Our Ref: 025-2031 WEPA - PAN-026789 Schedule 5 Response-2 REV00

**WEPA UK Ltd – PAN-026789 (EPR/EP3738NG/V006) Schedule 5 Response (2)**

Many thanks for your Schedule 5 dated 26<sup>th</sup> September 2025 (Ref. PAN-026789 Schedule 5 Notice-2). Our responses to the various questions and requests are outlined below.

**Figure 1: WWTP Systems**

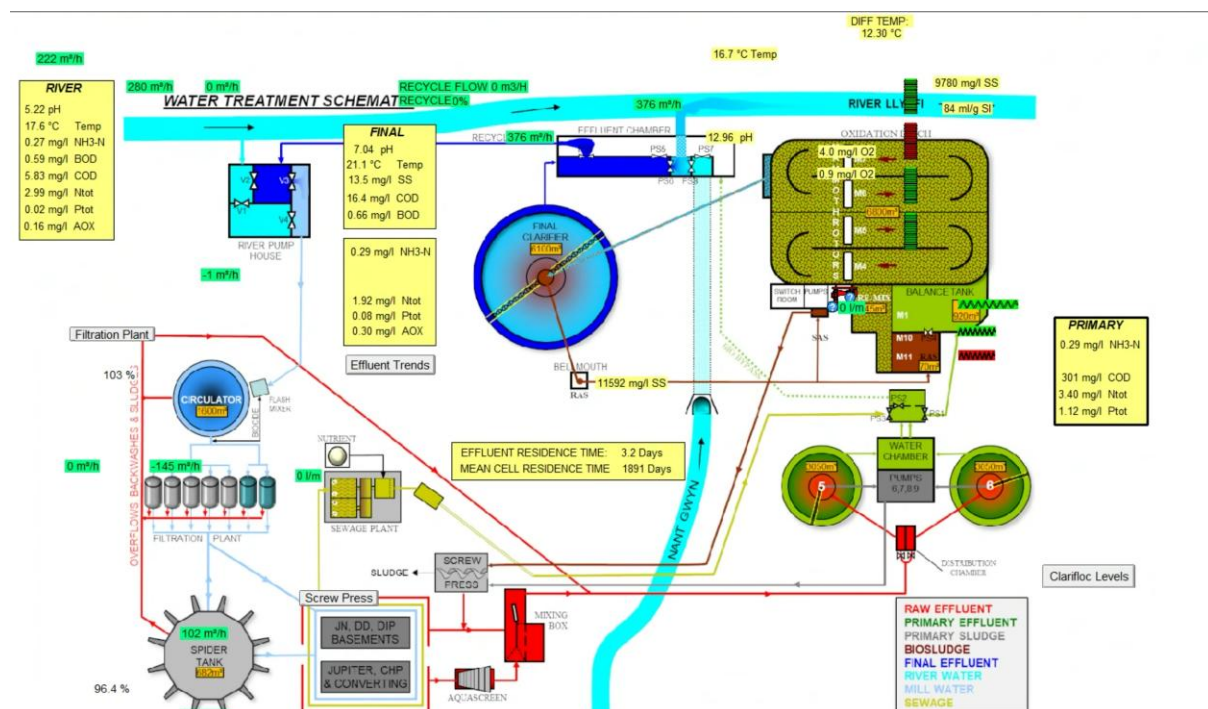
NRW iii. Outline the capacity of each of the stages of the firewater containment and that these stages can handle the volumes required to extinguish the fire.

- Hardstanding (including the c. 1-metre-high bund wall) – a surface area of c. 4500 m<sup>2</sup> (assuming 50% is available, a conservative estimate) to a maximum depth of ½ metre across the pad, conservative estimate) this equates to 1,125 m<sup>3</sup>.
- Attenuation crate – 180 m<sup>3</sup>.
- One of the primary flocculators will always be kept empty and will only be used in an emergency (capacity of 3,050 m<sup>3</sup>) (**Figure 1**).

The combined total storage is therefore 4,355 m<sup>3</sup>.

The maximum proposed broke storage capacity is 506 tonnes (at a density of 0.75) or 380 m<sup>3</sup> of material. Assuming the NRW application rate/period, this equates to 456 m<sup>3</sup> of firewater (over 3 hours). A conservative estimate shows that there is ample space within the engineered systems.
